ENGINEERING CHANGE PROPOSAL

ECP NUMBER	TITLE
BC-M/O-3689	Bayou Choctaw Relief System Flange Replacement

BAYOU CHOCTAW RELIEF SYSTEM FLANGE REPLACEMENT

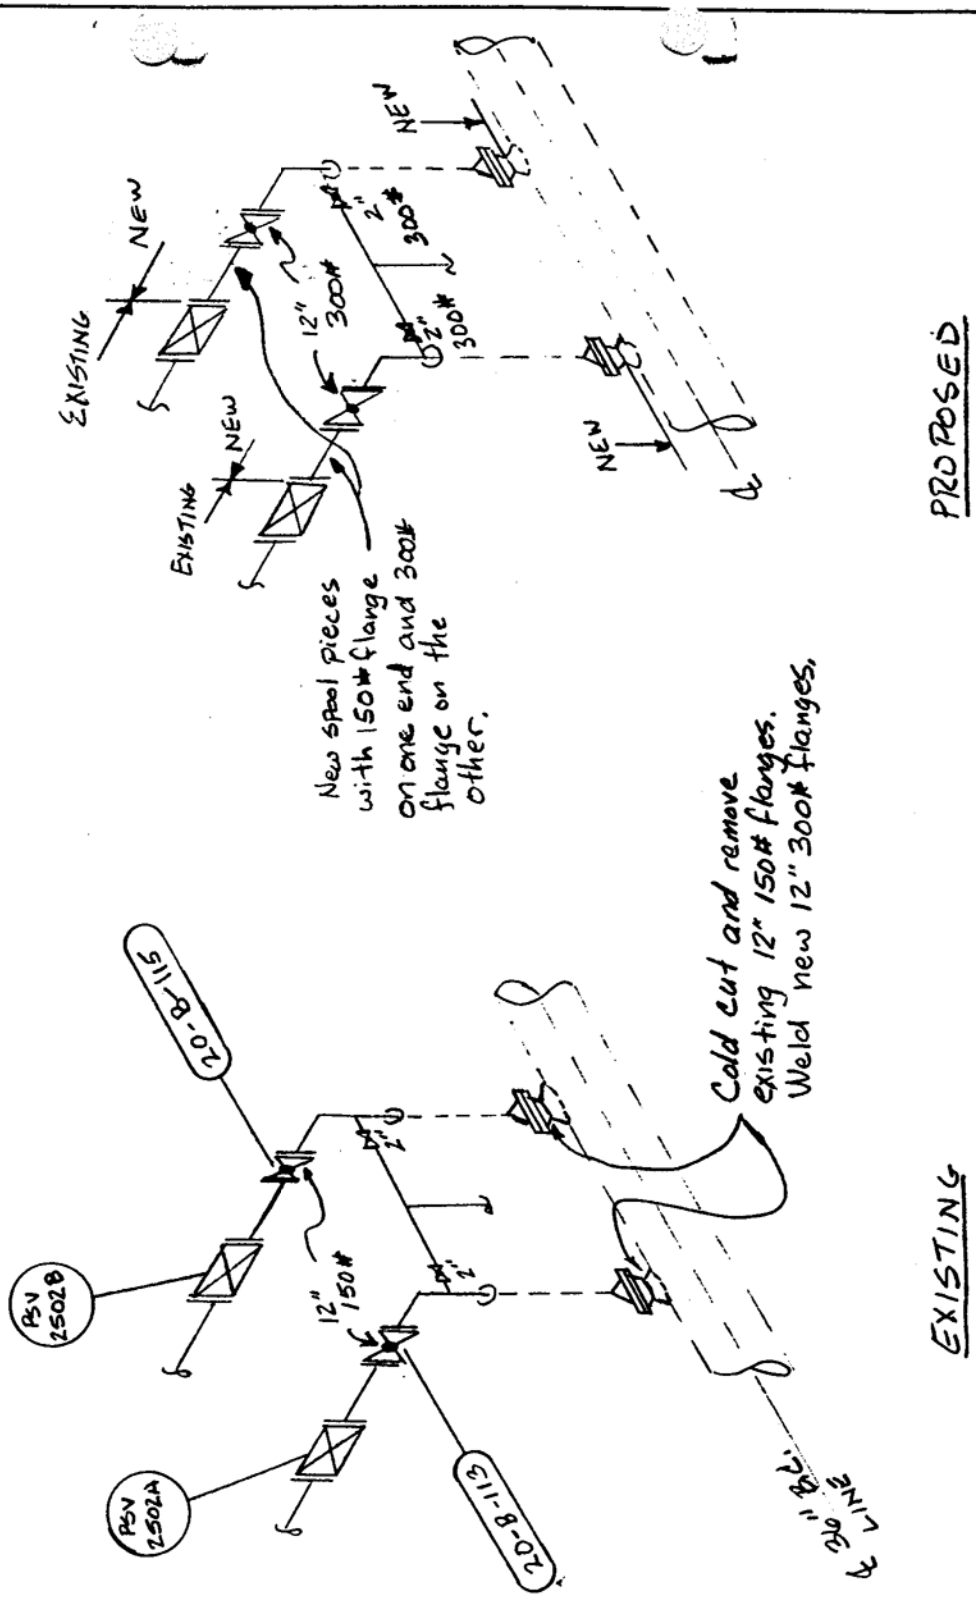
The 12" piping for the surge relief system on the Bayou Choctaw Pipeline at St. James is an ANSI 150 system. This allows only a 285 psi MAOP for the pipeline.

The piping between PSV-2502A and the pipeline and PSV-2502B and the pipeline will be removed and replaced with ANSI 300 piping, valves, and fittings in the same arrangement. See the attached P&ID # SJ-M-103-018 and attached isometric sketch for details of the change.

300 psi MAOP for the pipeline cannot be achieved with ANSI 150 flanges on the line.
